Contract Change Order No4

Project Number:90.19004

Project Name:City Hall Interior Renovation Project

SIGNAL HILL CITY HALL WINDOW REPLACEMENT

WINDOW SCHEDULE AND WINDOW ELEVATIONS

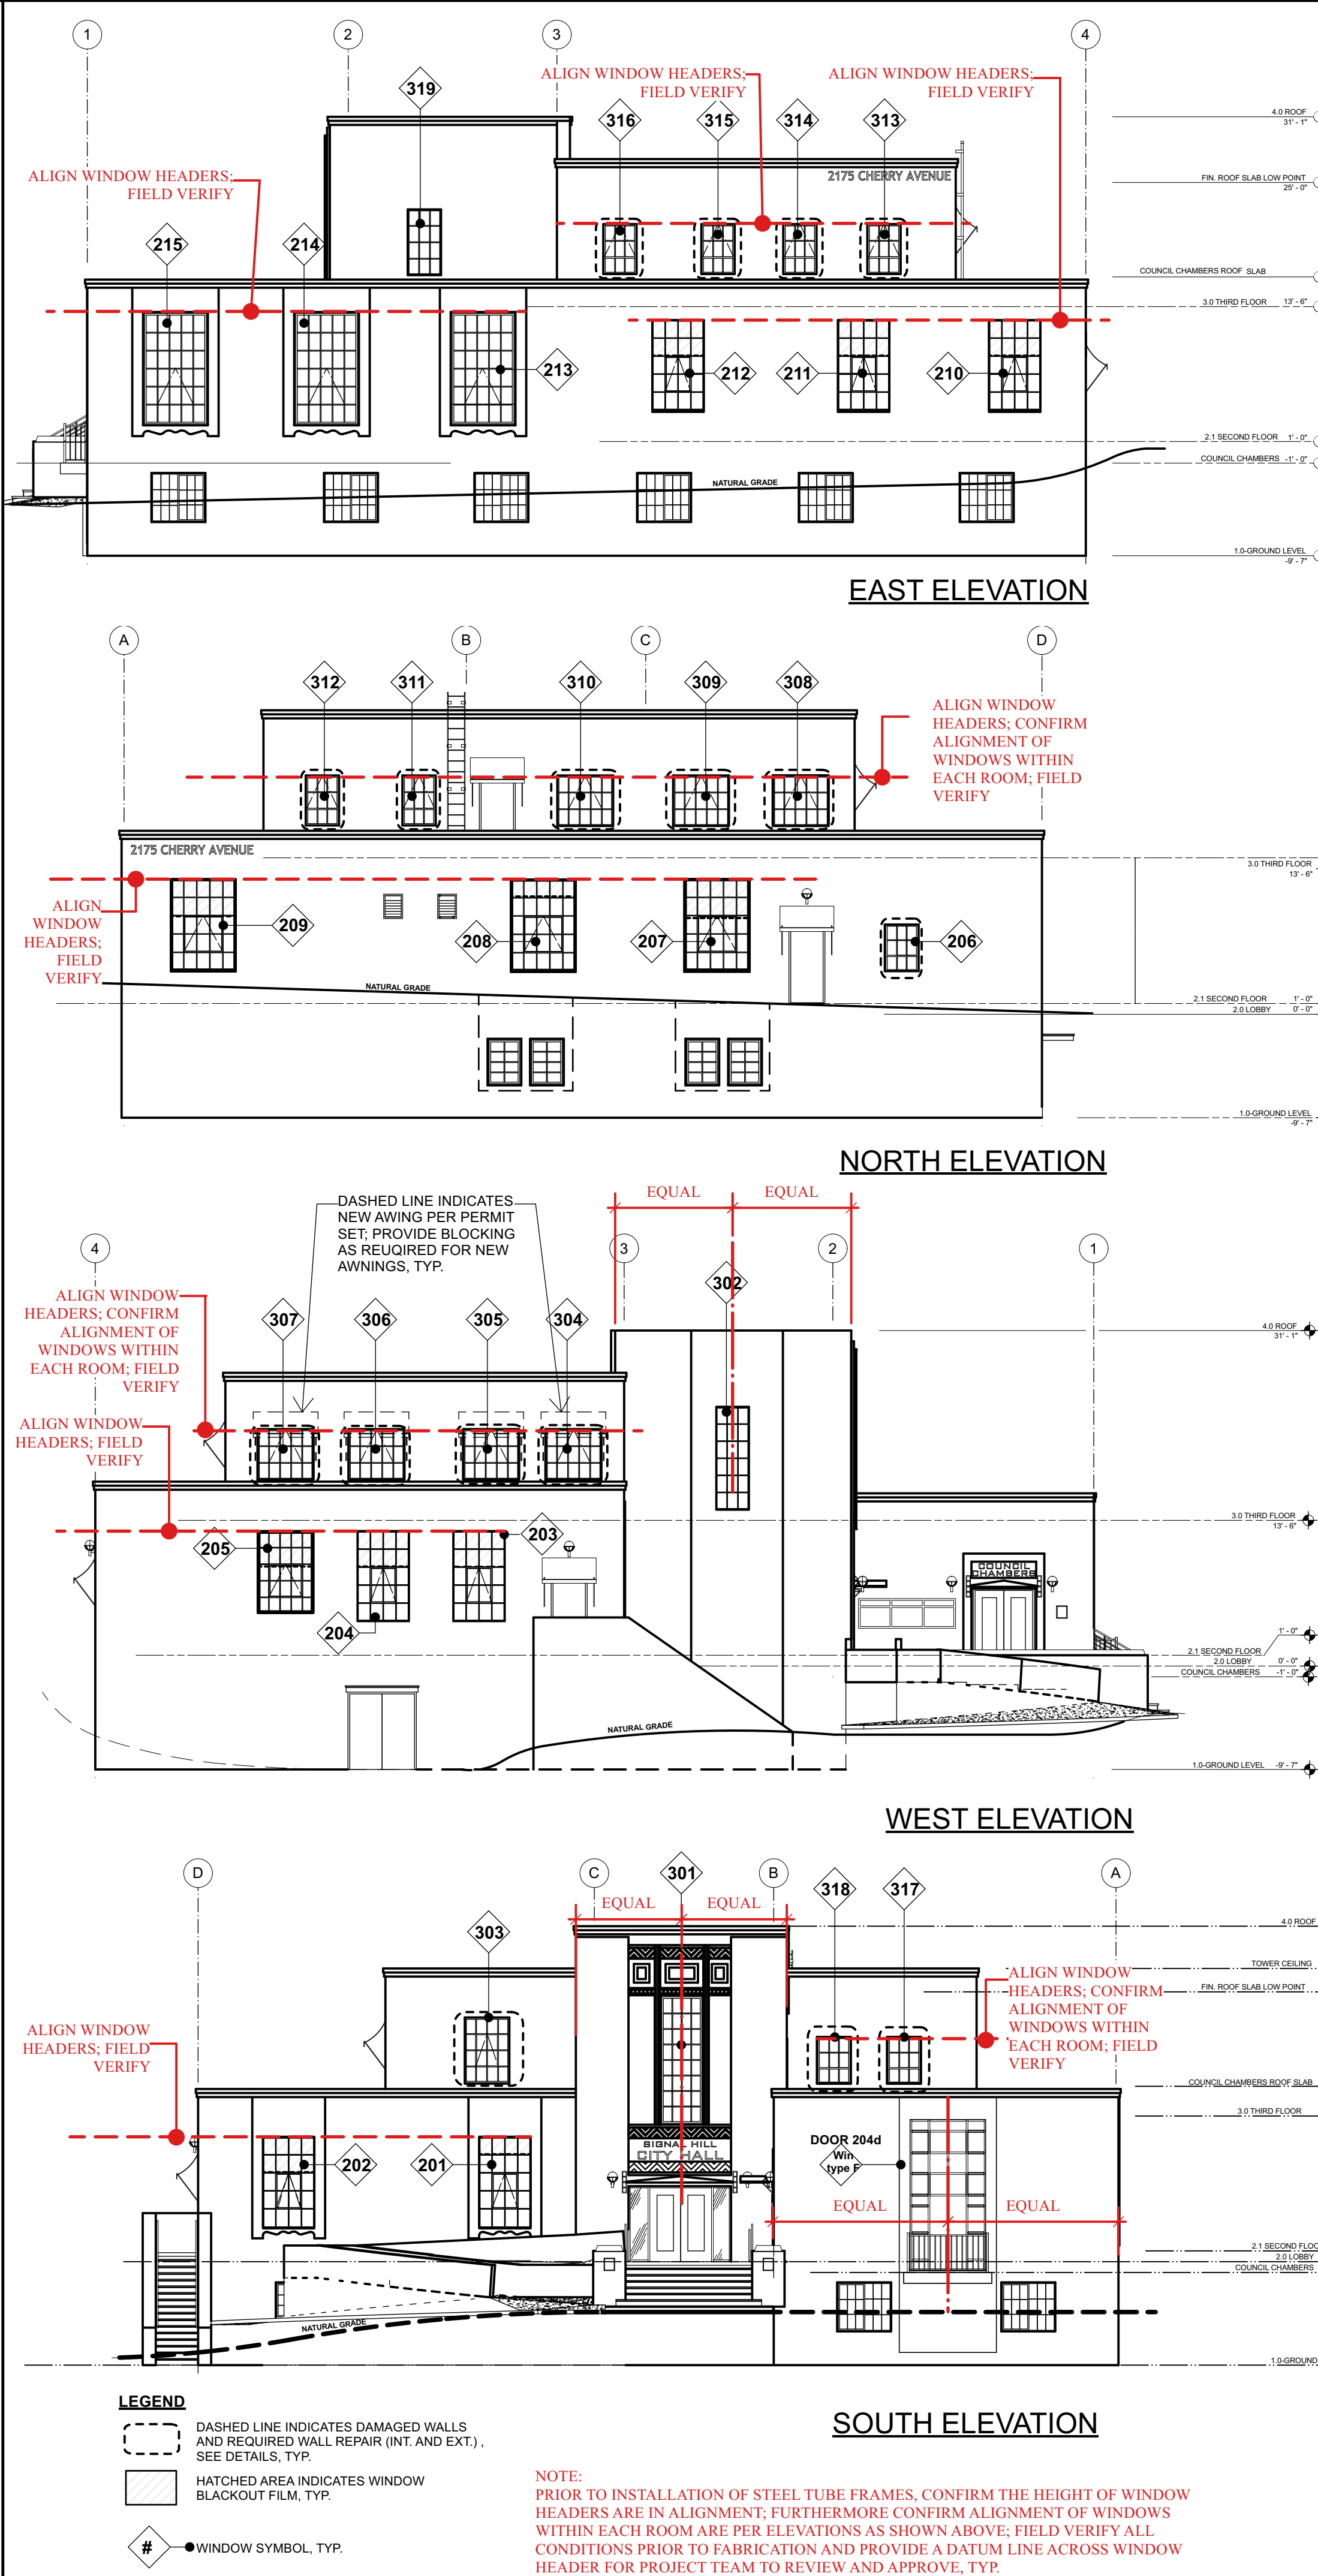
Item No.	Description	Change Order Quantity	Unit	Unit Cost	Change Order Cost	Add'l Working Days
1	Window A - Additional demolition of drywall/plaster, welding of steel framing around the opening; installation of double sill, additional stucco and drywall patching, and sloped edge concrete installation for proper drainage. Work completed per the scope outlined in the Steel Window Replacement Plan Set and Contractor's Change Order No. 367 (CCO #367).	4	EA	\$ 4,460.00	\$ 17,840.00	130
2	Window B - Additional demolition of drywall/plaster, welding of steel framing around the opening; installation of double sill, additional stucco and drywall patching, and sloped edge concrete installation for proper drainage. Work completed per the scope outlined in the Steel Window Replacement Plan Set and Contractor's Change Order No. 367 (CCO #367).	5	EA	\$ 5,120.00	\$ 25,600.00	
3	Window D - Additional demolition of drywall/plaster, welding of steel framing around the opening; installation of double sill, additional stucco and drywall patching, and sloped edge concrete installation for proper drainage. Work completed per the scope outlined in the Steel Window Replacement Plan Set and Contractor's Change Order No. 367 (CCO #367).	4	EA	\$ 5,550.00	\$ 22,200.00

4	Window D1 - Additional demolition of drywall/plaster, welding of steel framing around the opening; installation of double sill, additional stucco and drywall patching, and sloped edge concrete installation for proper drainage. Work completed per the scope outlined in the Steel Window Replacement Plan Set and Contractor's Change Order No. 367.	7	EA	\$ 5,770.00	\$ 40,390.00	
5	Window D2 - Additional demolition of drywall/plaster, welding of steel framing around the opening; installation of double sill, additional stucco and drywall patching, and sloped edge concrete installation for proper drainage. Work completed per the scope outlined in the Steel Window Replacement Plan Set and Contractor's Change Order No. 367.	4	EA	\$ 6,500.00	\$ 26,000.00

6	Window D3 - Additional demolition of drywall/plaster, welding of steel framing around the opening; installation of double sill, additional stucco and drywall patching, and sloped edge concrete installation for proper drainage. Work completed per the scope outlined in the Steel Window Replacement Plan Set and Contractor's Change Order No. 367.	7	EA	\$ 4,980.00	\$ 34,860.00	
7	Window G - Additional demolition of drywall/plaster, welding of steel framing around the opening; installation of double sill, additional stucco and drywall patching, and sloped edge concrete installation for proper drainage. Work completed per the scope outlined in the Steel Window Replacement Plan Set and Contractor's Change Order No. 367.	2	EA	\$ 5,750.00	\$ 11,500.00	
8	Window H - Additional demolition of drywall/plaster, welding of steel framing around the opening; installation of double sill, additional stucco and drywall patching, and sloped edge concrete installation for proper drainage. Work completed per the scope outlined in the Steel Window Replacement Plan Set and Contractor's Change Order No. 367.	1	EA	\$ 6,870.00	\$ 6,870.00

9	New Window F - installation, materials, supplies and labor. Scope includes demolition of drywall/plaster, welding of steel framing around the opening; installation of double sill, stucco and drywall patching, and sloped edge concrete installation for proper drainage. Work completed per the scope outlined in the Steel Window Replacement Plan Set and Contractor's Change Orders No. 367 and No. 0002	1	LS	\$ 59,000.12	\$ 59,000.12	
10	Frame of new soffit on the 2nd floor with metal studs in order to run Hvac ducts to 2nd floor offices. Drywall and mud new soffit. Work completed per Contractor's Change Order No. 0003	1	LS	\$ 11,021.73	\$ 11,021.73	
Estimated Total of This Change Order:					\$ 255,281.85	130
PAYMENT FOR THIS WORK WILL BE MADE BASED ON FIELD MEASURED QUANTITIES AT THE ADJUSTED CONTRACT UNIT PRICES LISTED ABOVE AND THE TOTAL COST MAY DIFFER FROM THE ESTIMATED AMOUNT SHOWN ABOVE.

ALTERNATIVE DETAIL FOR REPLACEMENT OF DAMAGED FRAMING BEYOND REPAIR AT HEADER

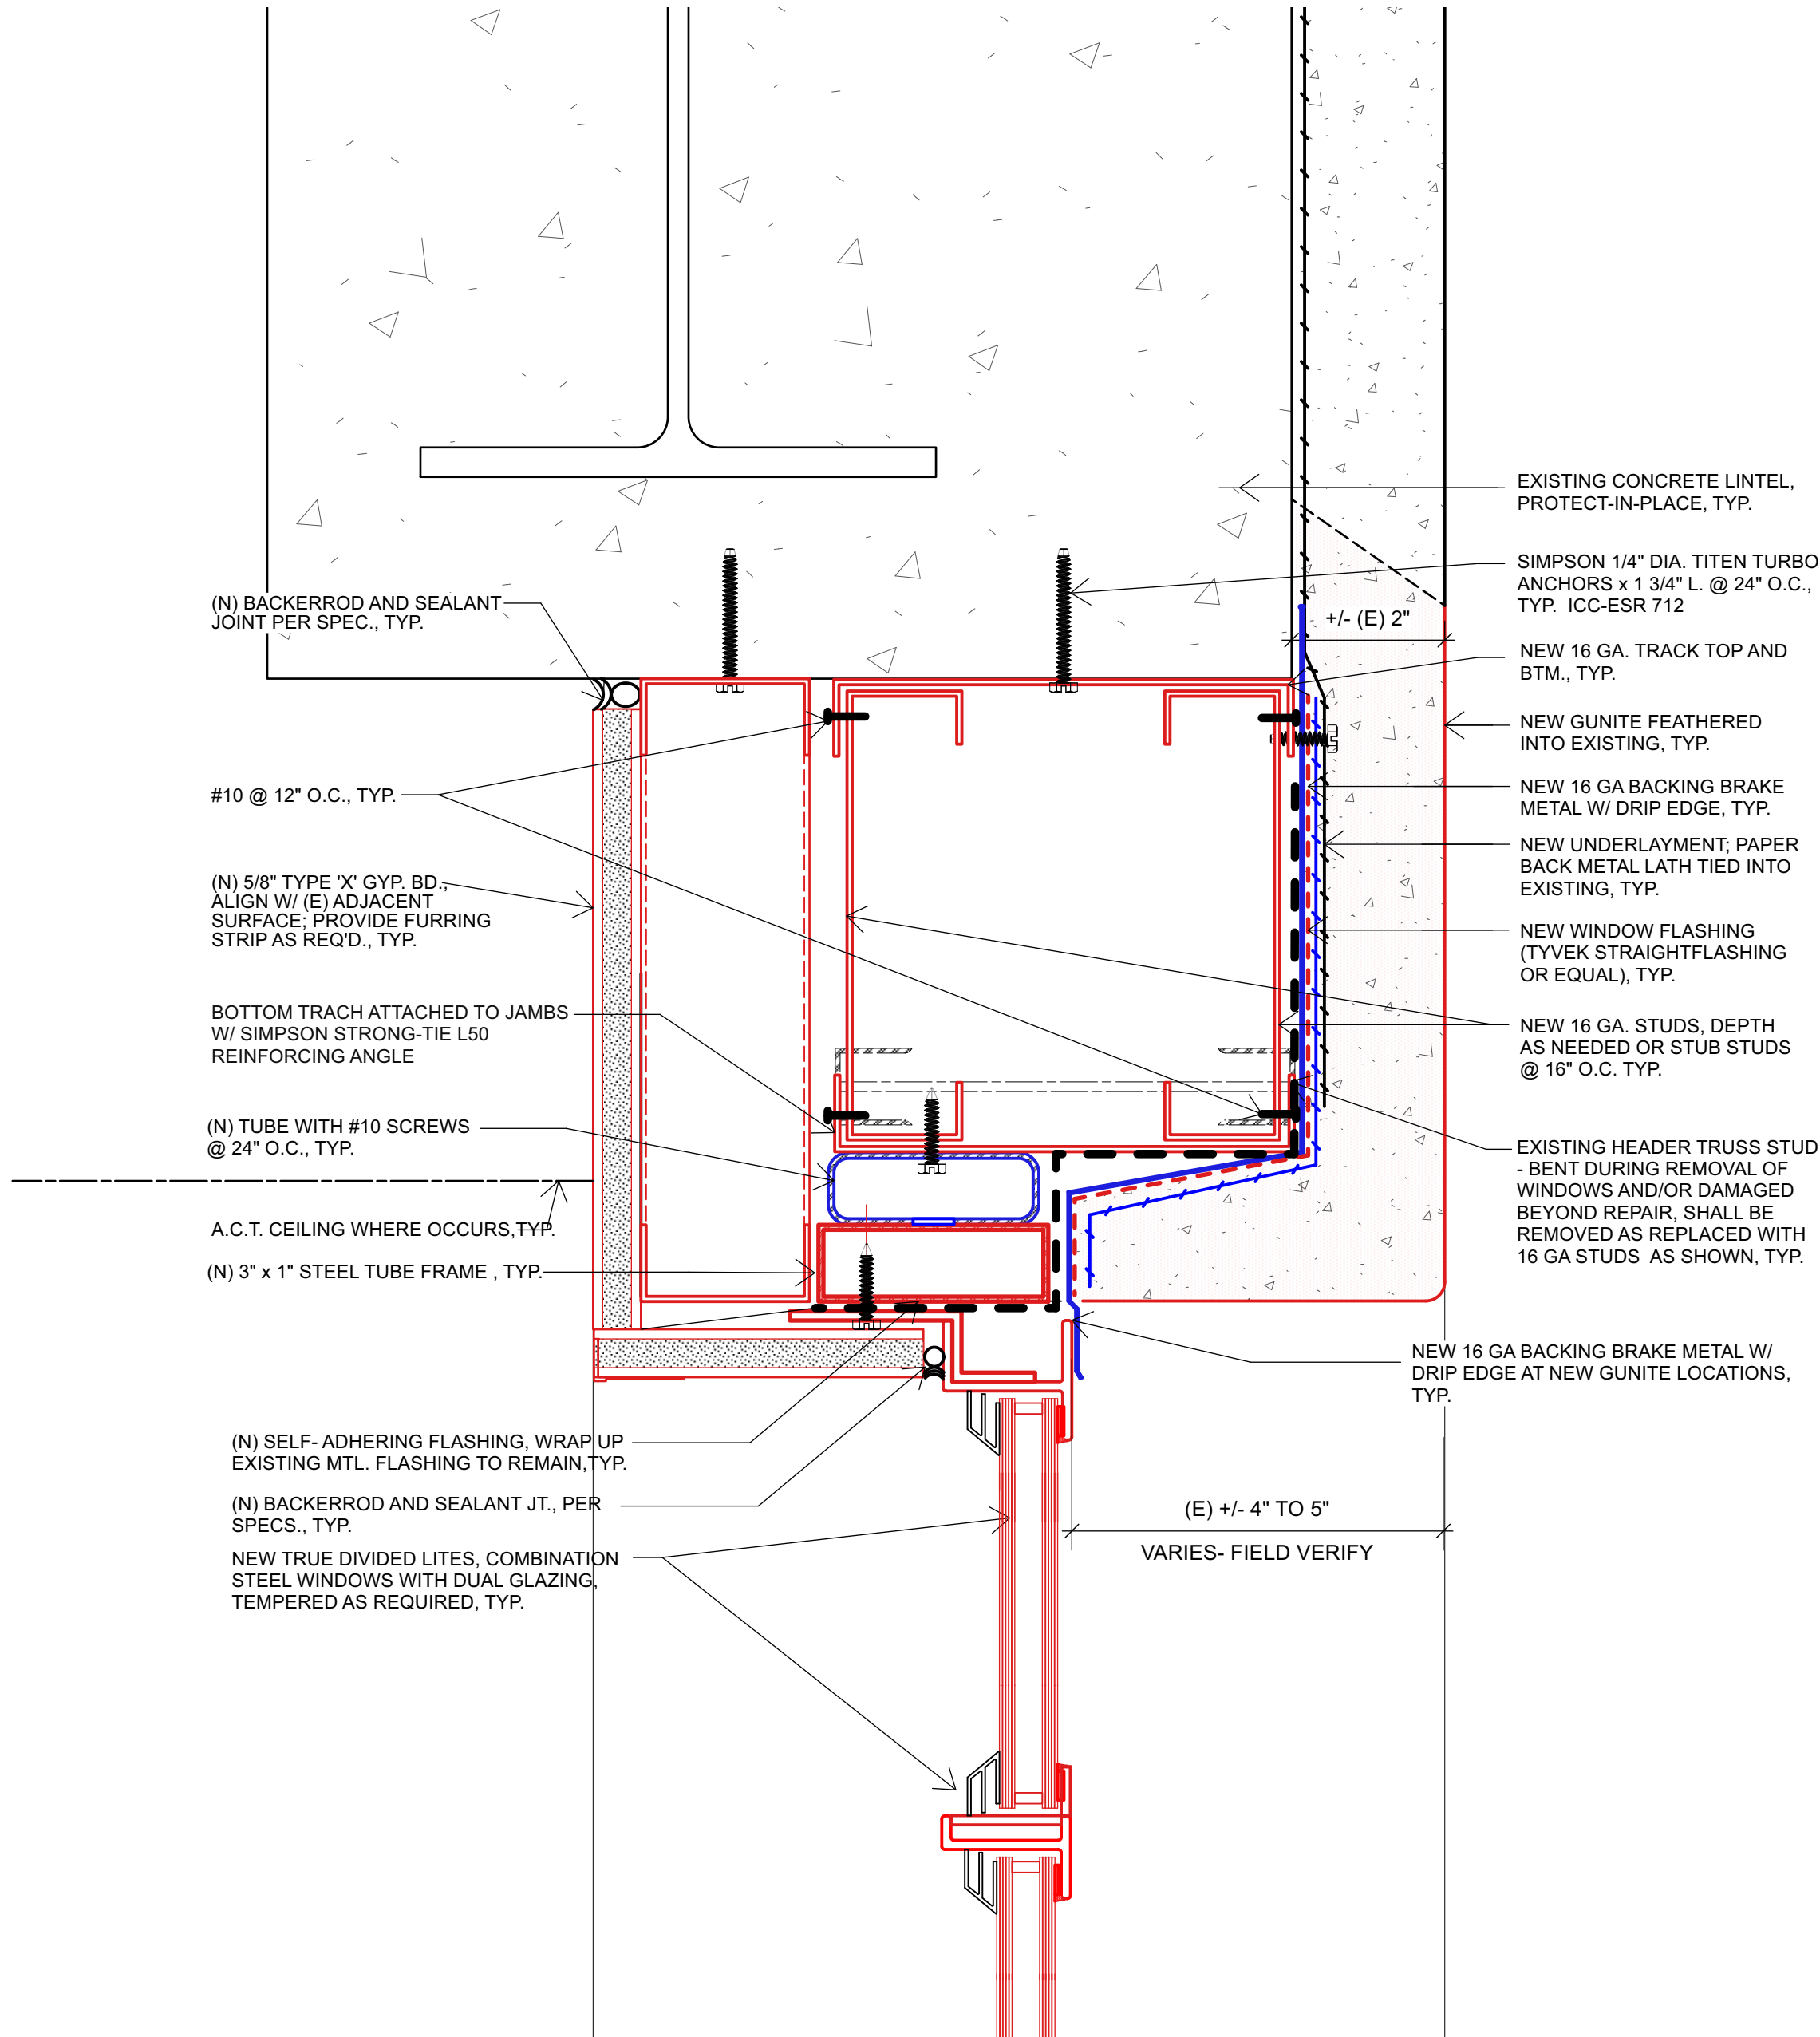
- NOTES:
1. PROVIDE NEW BLOCKING AT WINDOWS TO HAVE NEW AWINGS AT 3RD FLOOR, TYP.
 2. ALL INTERIOR FINISHES REMOVED SHALL BE REPLACED WITH "IN-KIND" TO MATCH EXISTING ADJACENT SURFACE, TYP.
 3. PROVIDE BACKERROD AND SEALANT JOINT TYPICAL ALL AROUND WINDOWS, PAINT TO MATCH ADJACENT SURFACE,TYP.
 4. PREP, PRIME, AND PAINT INTERIOR WALL FINISHES, TYP.
 5. ALL WELDS TO BE FIELD SPOTS WELDS W/ SPECIAL INPECTOR, TYP.
 6. REFER TO GENERAL NOTES FOR ADD'L. INFO., TYP.
 7. REFER TO SCHEDULE FOR ADD'L. INFO., TYP.
 8. NEW GUNITE TO MATCH EXISTING 'IN-KIND", TYP.
